**Pacific Gas and
Electric Company**

PG&E Letter DCL-04-178

Docket No. 50-275, OL-DPR-80
Docket No. 50-323, OL-DPR-82
Diablo Canyon Units 1 and 2
License Amendment Request 04-09
Relocation of Technical Specification Cycle Specific Parameters to the Core
Operating Limits Report

Figure 2.1.1-1
REACTOR CORE SAFETY LIMIT

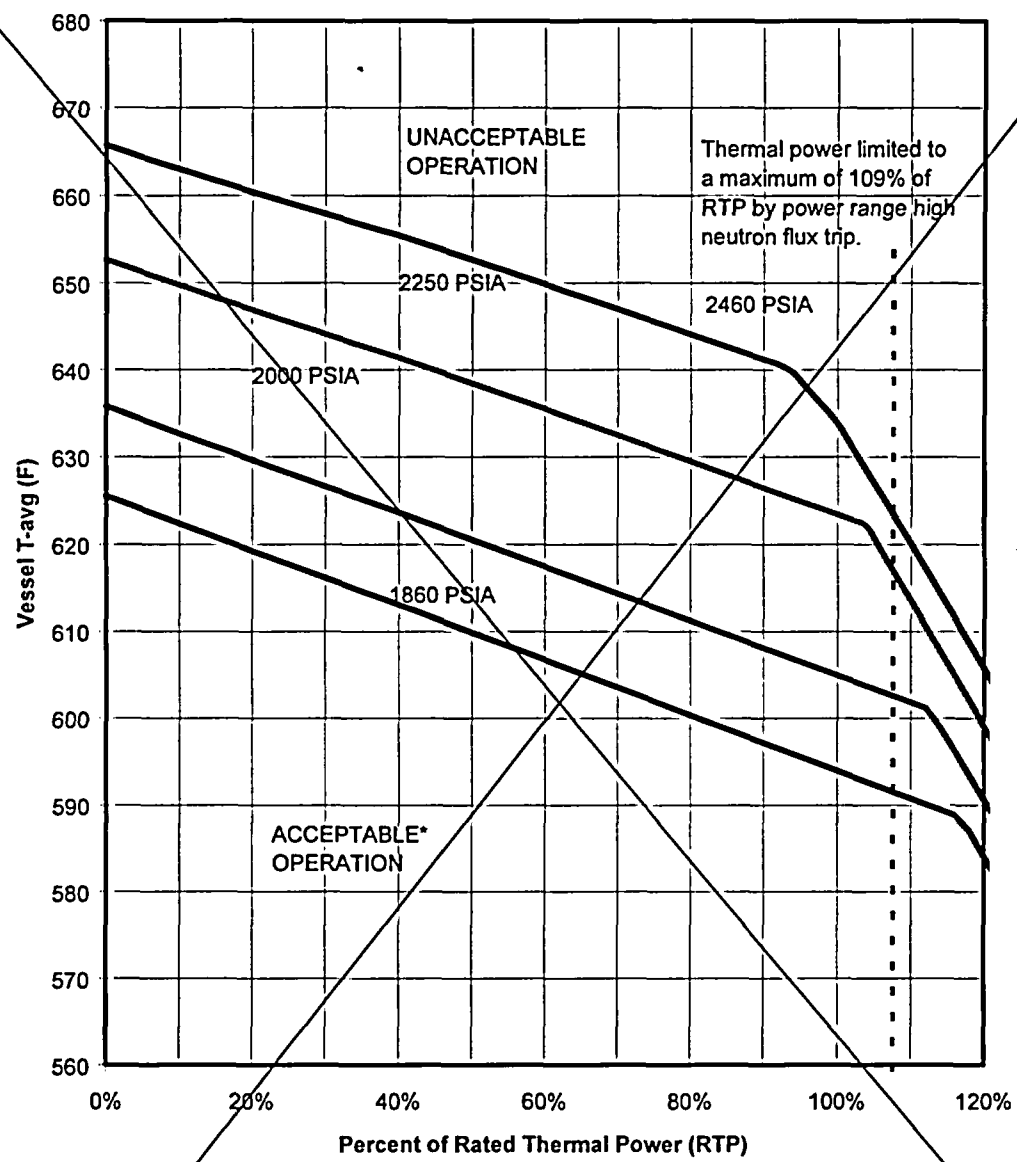
Delete

*When operating in the reduced RTP region of Technical Specification LCO 3.4.1 (Table 3.4.1-1 for Unit 1 and Table 3.4.1-2 for Unit 2) the restricted power level must be considered 100% for this Figure.

the COLR; and the following SLs shall not be exceeded:

2.1.1.1 The departure from nucleate boiling ratio (DNBR) shall be maintained ≥ 1.17 for the WRB-1/WRB-2 DNB correlations.

2.1.1.2 The peak fuel centerline temperature shall be maintained $< 5080^{\circ}\text{F}$, decreasing by 58°F per 10,000 MWD/MTU of burnup.

Table 3.3.1-1 (page 6 of 7)
Reactor Trip System Instrumentation

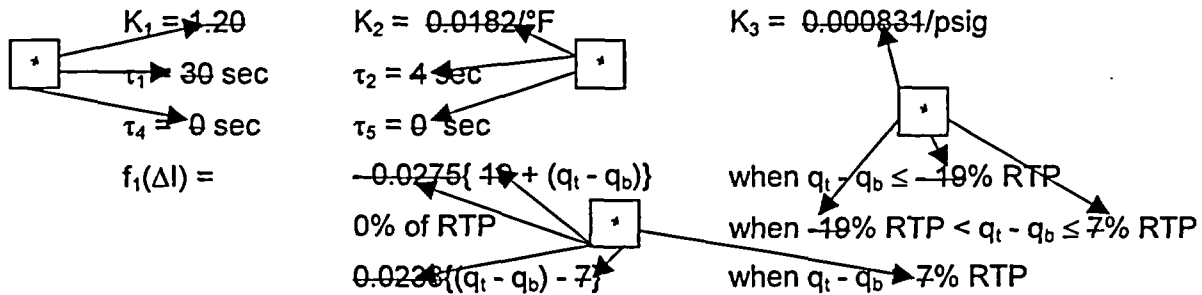
Note 1: Overtemperature ΔT

The Overtemperature ΔT Function Allowable Value shall not exceed the following Trip Setpoint by more than 0.46% of ΔT span for hot leg or cold leg temperature inputs, 0.14% ΔT span for pressurizer pressure input, 0.19% ΔT span for ΔI inputs.

$$\Delta T \frac{(1 + \tau_4 s)}{(1 + \tau_5 s)} \leq \Delta T_0 \left\{ K_1 - K_2 \frac{(1 + \tau_1 s)}{(1 + \tau_2 s)} [T - T'] + K_3 (P - P') - f_1(\Delta I) \right\}$$

The values denoted with * are specified in the COLR

Table 3.3.1-1 (page 7 of 7)
Reactor Trip System Instrumentation

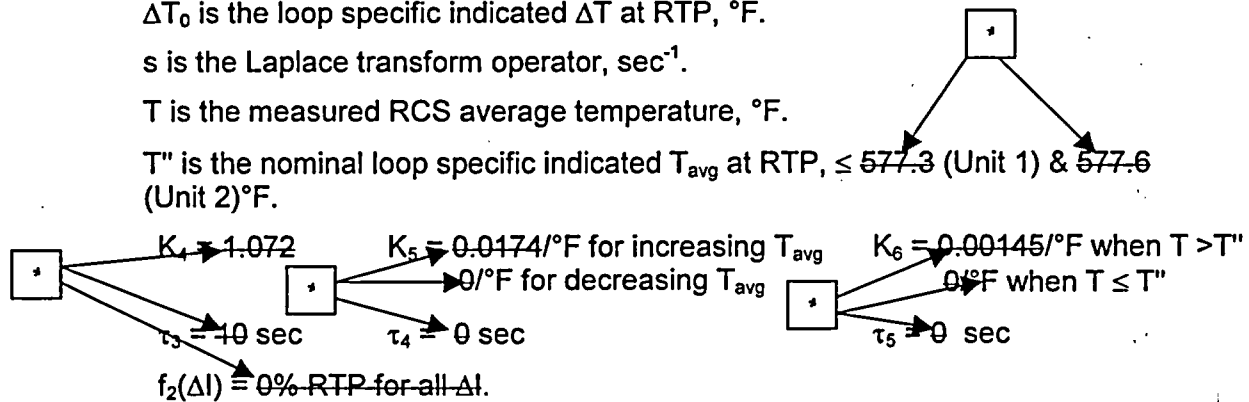
Note 2: Overpower ΔT

$$\Delta T \frac{(1+\tau_4 s)}{(1+\tau_3 s)} \leq \Delta T^0 \left\{ K_4 - K_5 \frac{\tau_3 s}{1+\tau_3 s} T - K_6 [T - T'] - f_2(\Delta I) \right\}$$

ΔT^0 is the loop specific indicated ΔT at RTP, °F.

The values denoted with * are specified in the COLR.
